AMERICAN FORK CITY
DEVELOPMENT REVIEW COMMITTEE AGENDA

Review and action on an application for a Preliminary Plat, known as Holmes Gunther Preliminary Plan for the proposed Ellen's 2 Subdivision, located at 490 N Mary Pulley Dr. (900 E), American Fork City, UT 84003. The Preliminary Plat will be on approximately 5.16 acres and will be in the R1-9000 zoning designation.

1. Address all comments and requirements from staff.
2. Add double inlet catch basins, modify storm drain storage system to one acceptable by the city easily maintainable and accessible, add line stops on water line, correct line type errors, identify to bury overhead power or confirm it's been removed, update details.

ELLEN'S 2 SUBDIVISION
HOLMES HOMES
COVER SHEET

SHEET NUMBER
01
OF 20 SHEETS
DRAWING NAME
TC01

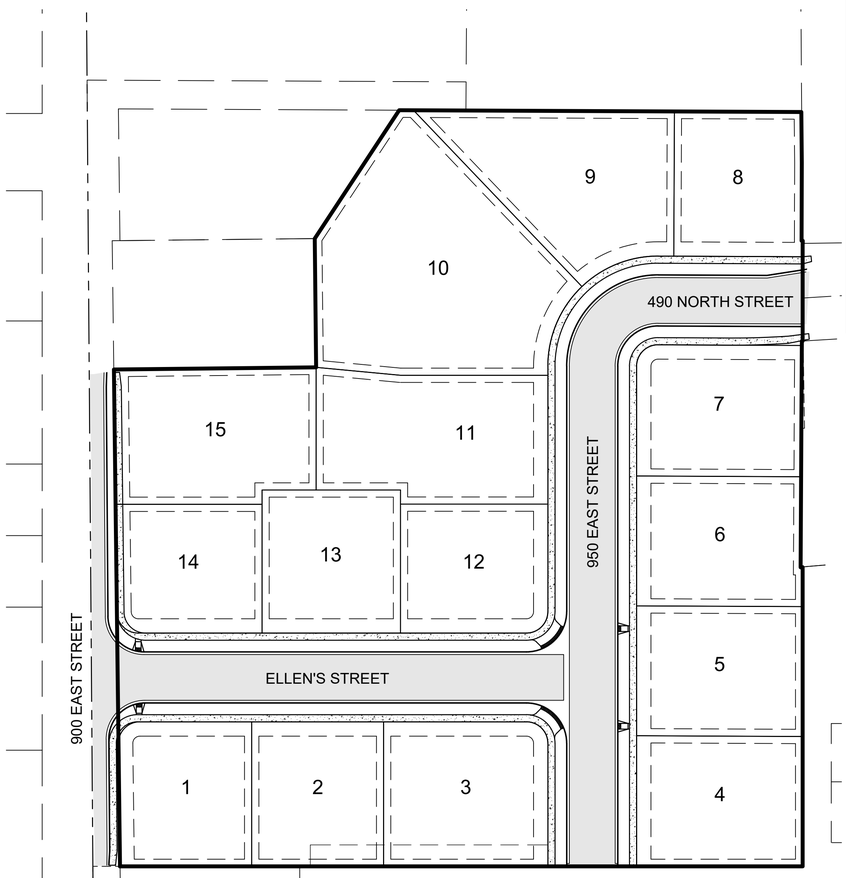
Provide project perimeter fencing.

SHEET NUMBER
08
OF 20 SHEETS
DRAWING NAME
PP01

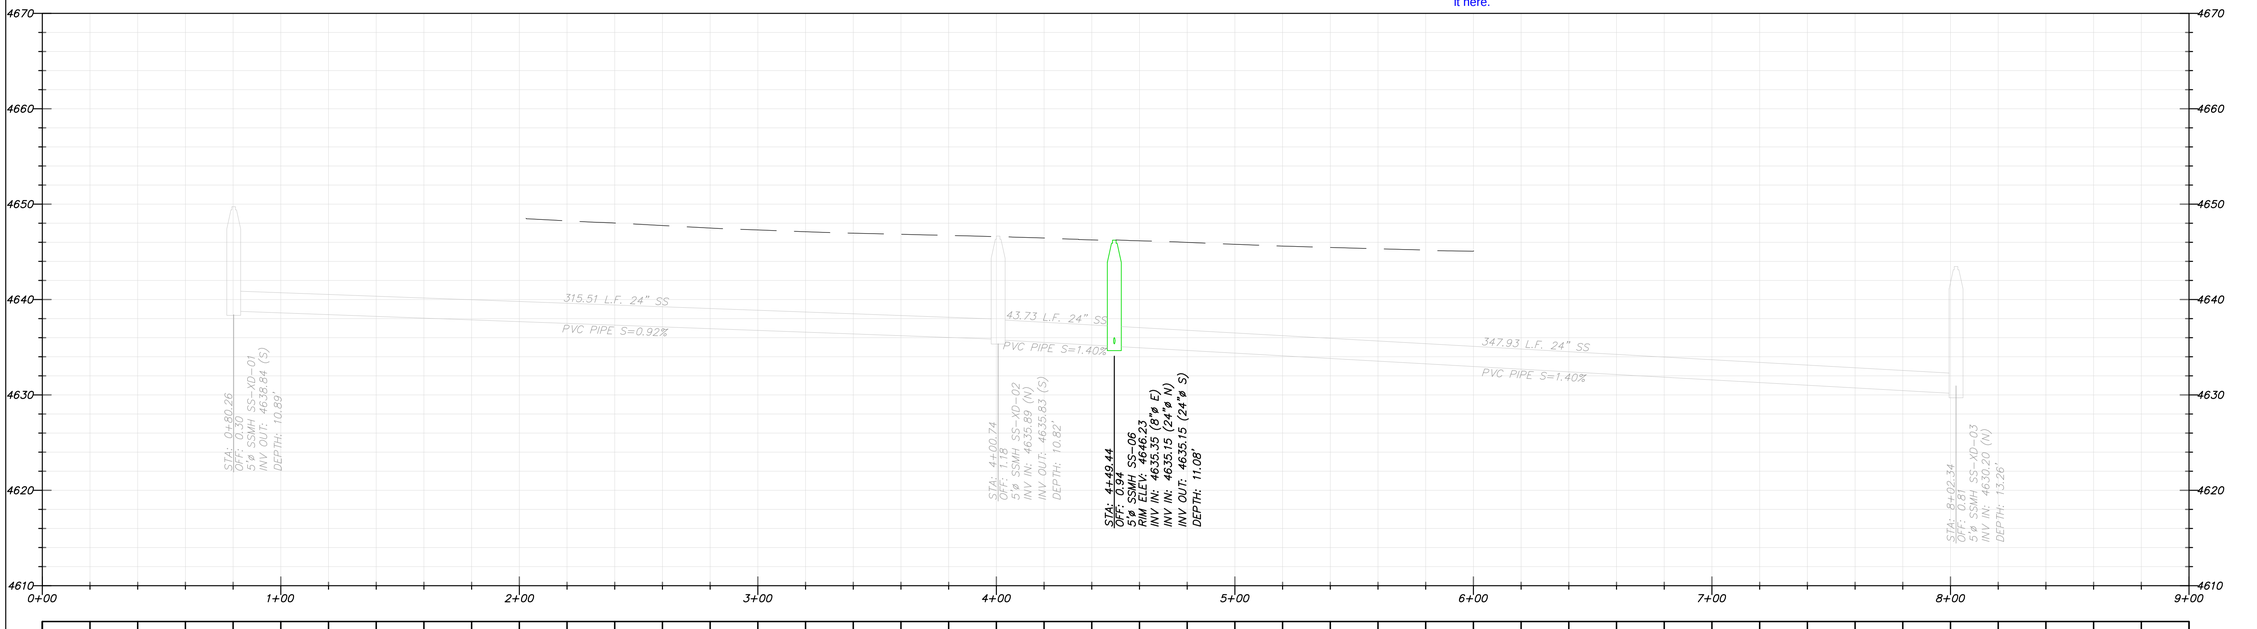
Since the previous submittal, this overhead powerline has been removed/frozen on this sheet. If this powerline still exists, it is best to still show it here.

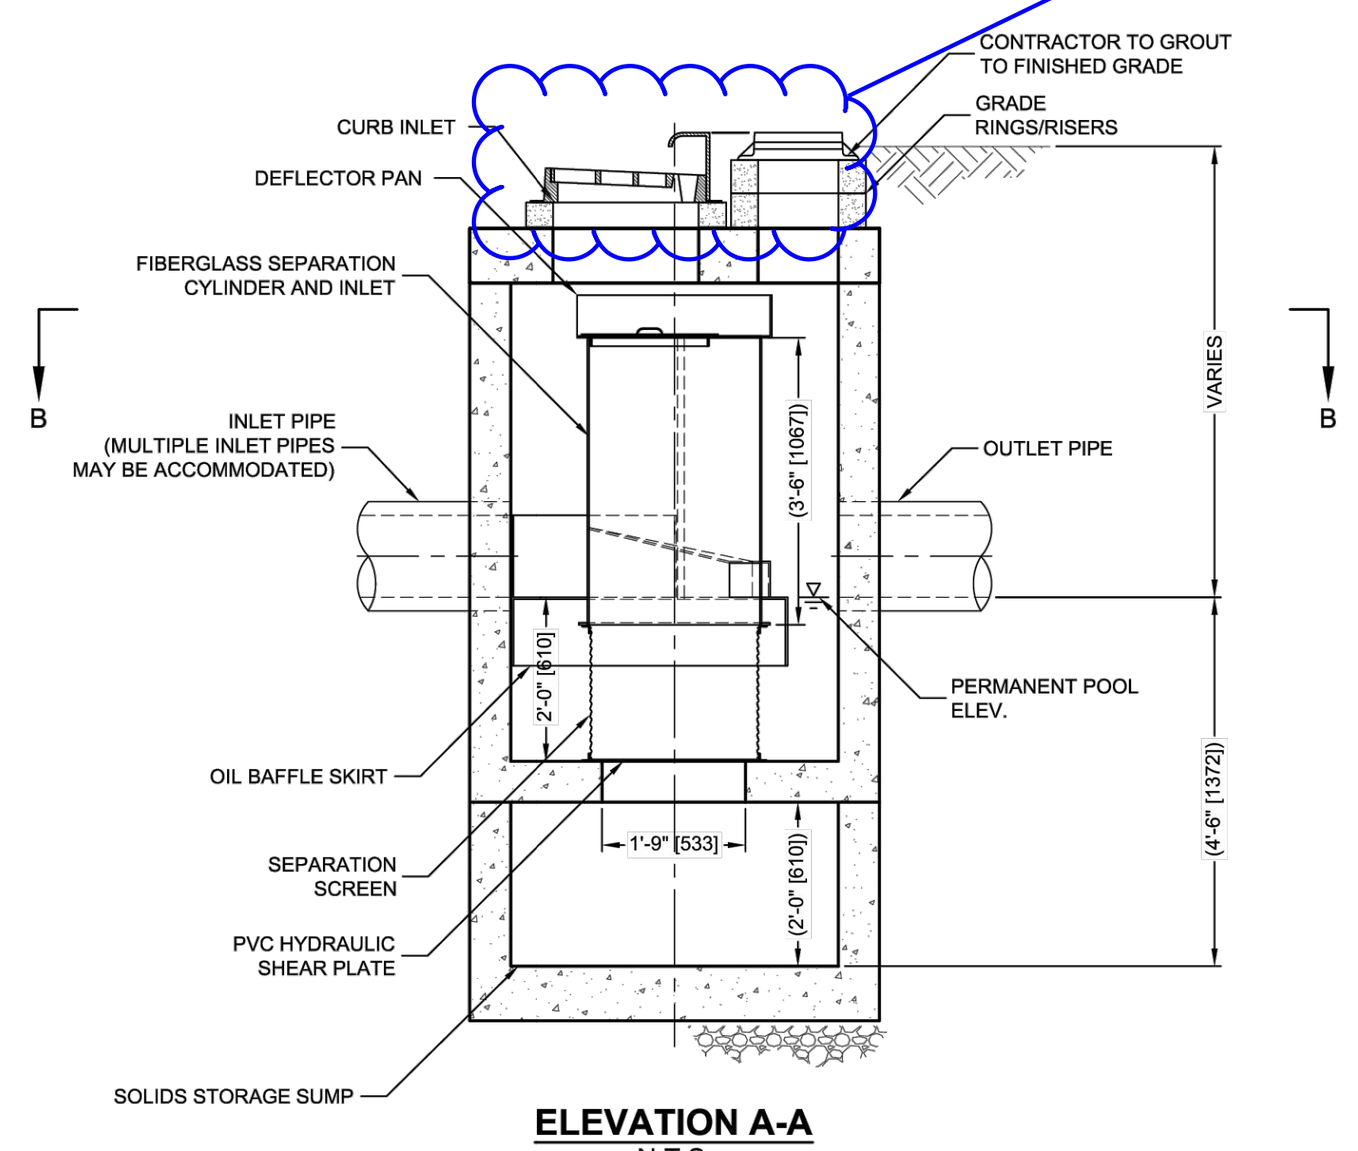
How will this design work if curb cuts are required for access?

ELLEN'S 2 SUBDIVISION

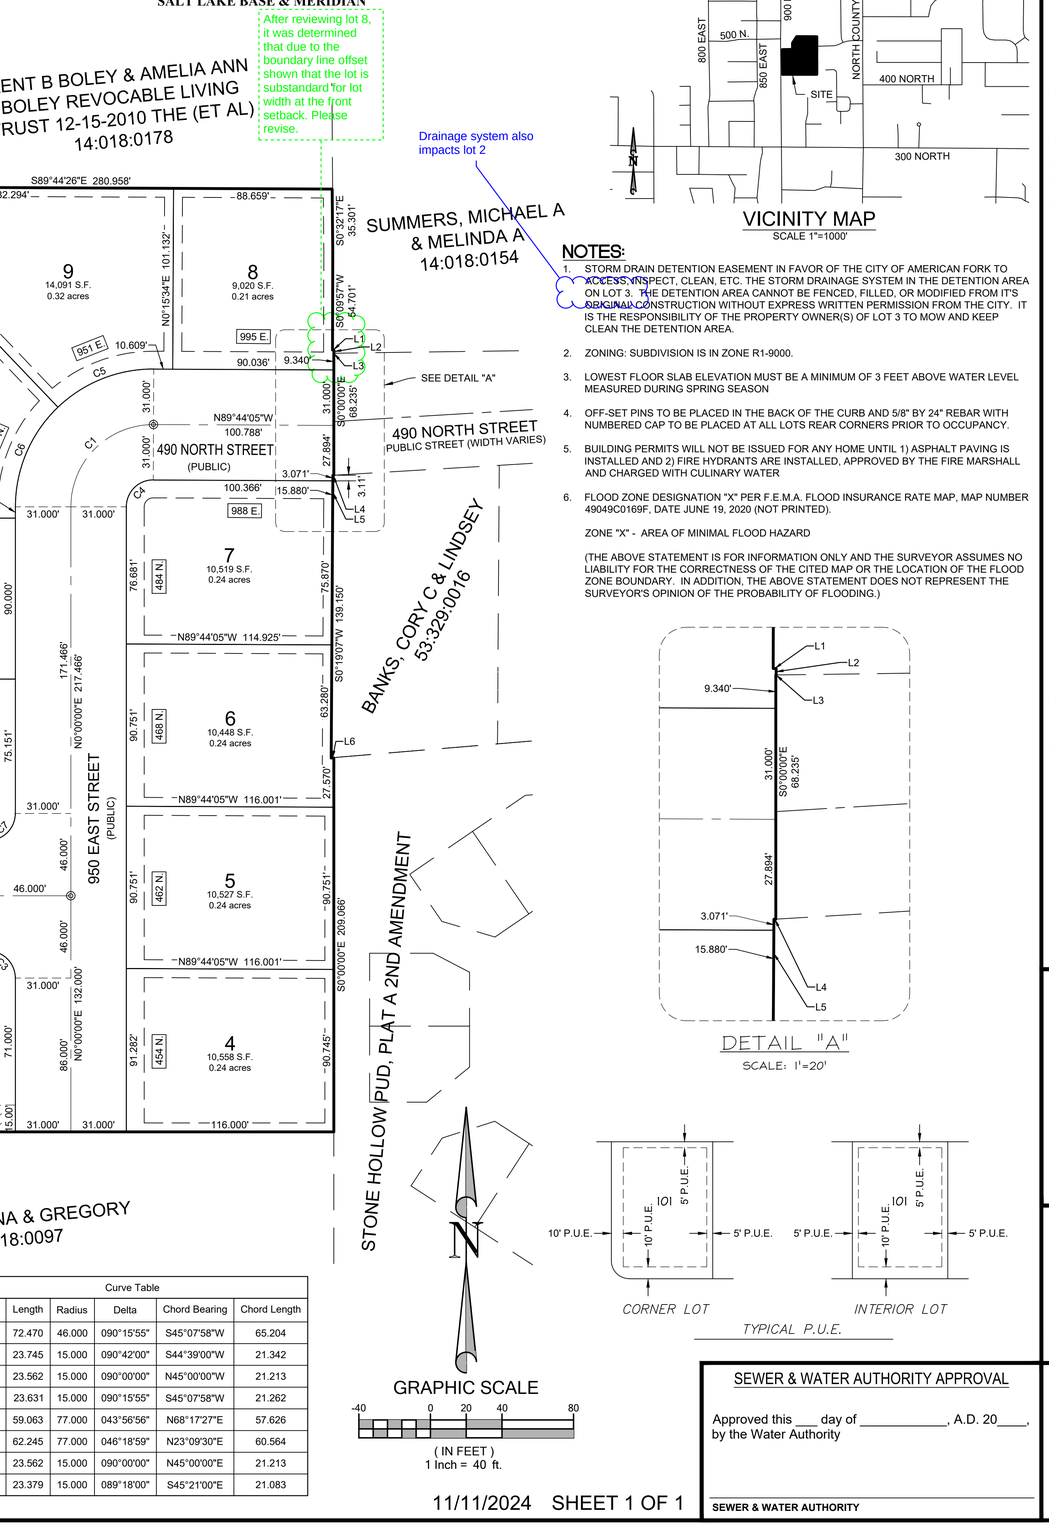
Planning Comments/Recommendations
1. Adjust all lots as called out in the initial review for R1-9000 zoning lot requirements.
2. Please add building envelopes for all lots. As there are irregular lots in this sub, we need to be able to see that the front lot width requirement is met at the front setback for all lots.
3. Please add perimeter fencing for the project.
4. Please show lot frontage that the direction of the front elevation of the home is aligned with the width requirement of the lots, starting with lots 1, 3, 7, 12, and 14.
5. Please revise lot 8 to show min width and depth requirements are met at the front setback.
